GE Hitachi Nuclear Energy

25A5675BA
Revision 5
November 2010

ABWR
Design Control Document
Tier 2

Question and Response Guide

Figure 20.3.15-1 Compressed Gas Systems Interconnections (Response to Question 430.217)

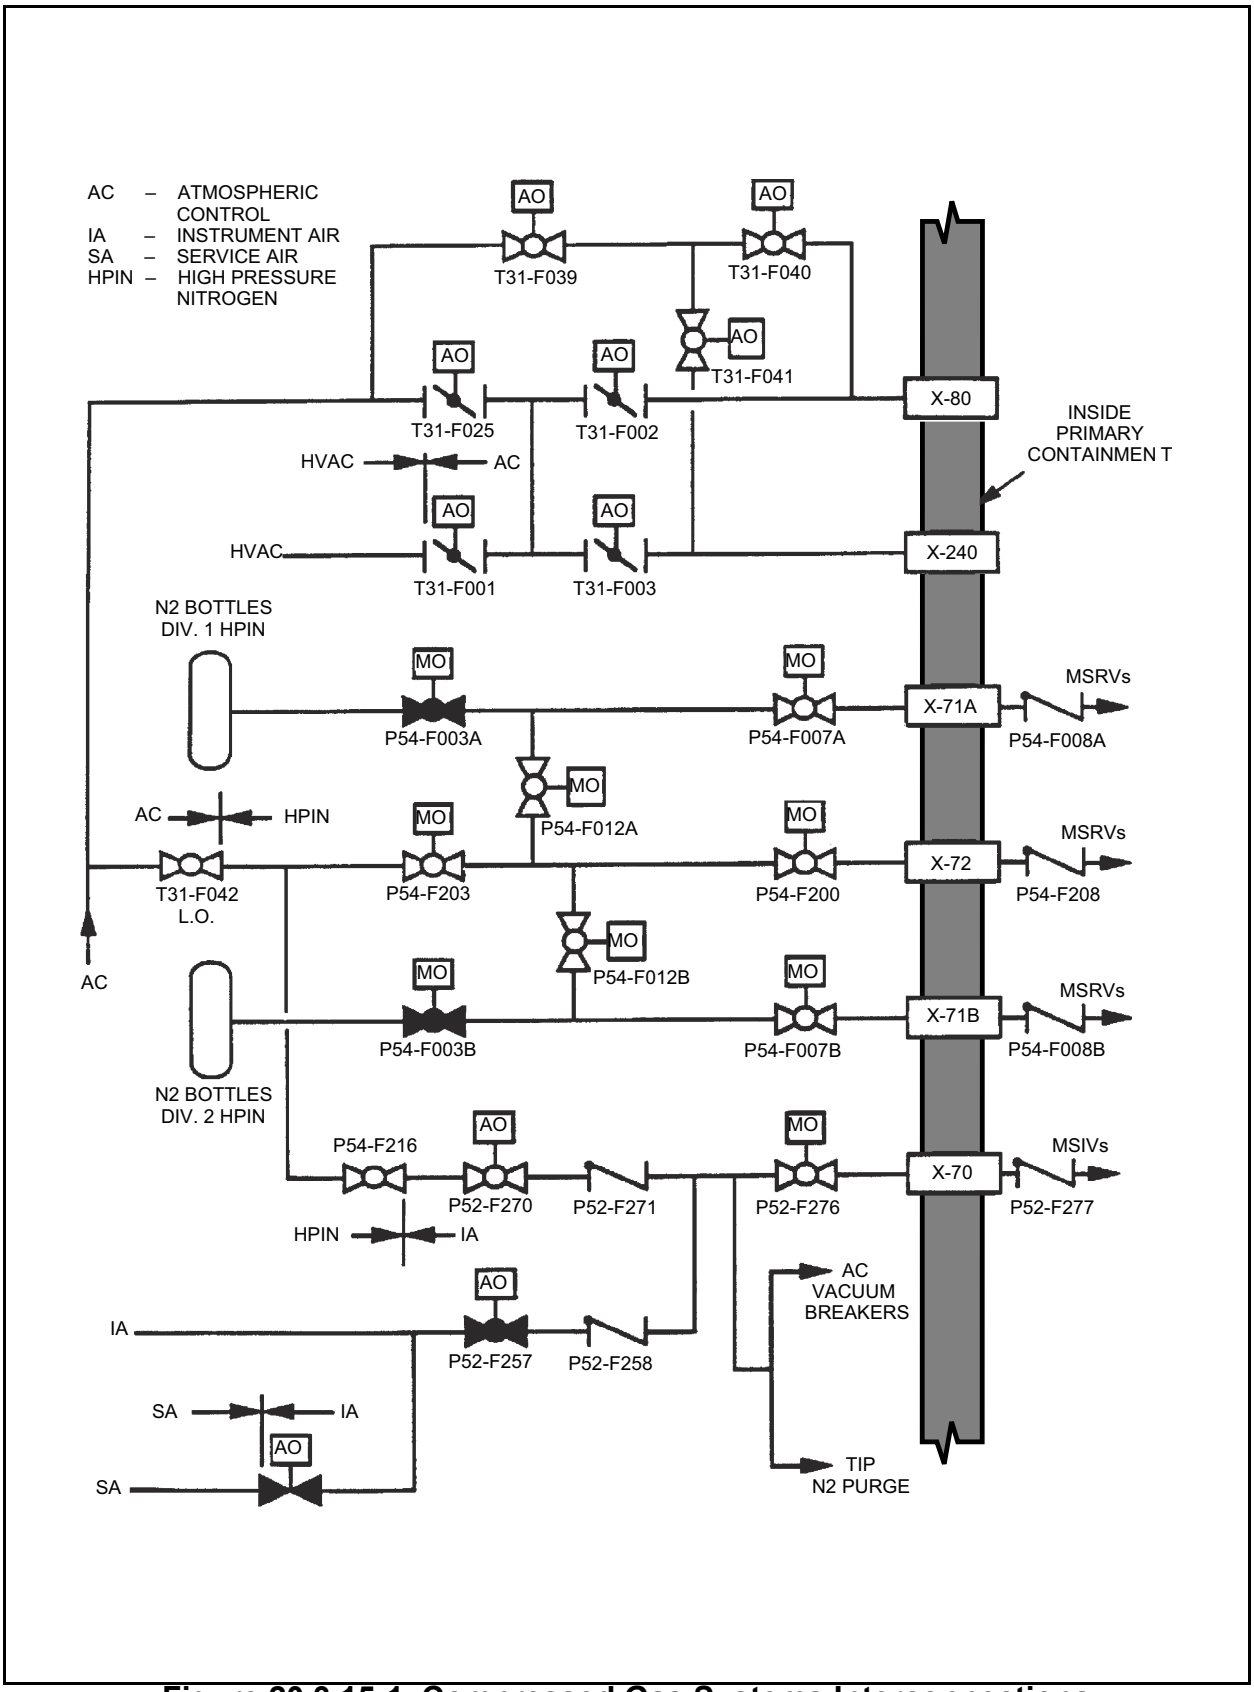
430.214
Contrary to what has been stated in ABWR SSAR Subsection 6.7.1, there is only one non-safety-related continuous nitrogen supply portion common to the two essential supply divisions (See Figure 6.7-1). Correct Subsection 6.7.1 as appropriate and discuss the effect of loss of nitrogen supply via the non-safety-related portion to all the equipment and components identified in SSAR Section 6.7.1 (e. g., Pneumatically operated valves and instruments inside the primary containment vessel) during normal operation. Clarify whether the pneumatic accumulator which provides the backup operating gas for the main steam isolation valve (See SSAR Subsection 5.4.5.2) is safety-grade for each valve. If not, justify the design. (9.3.1, 6.7)
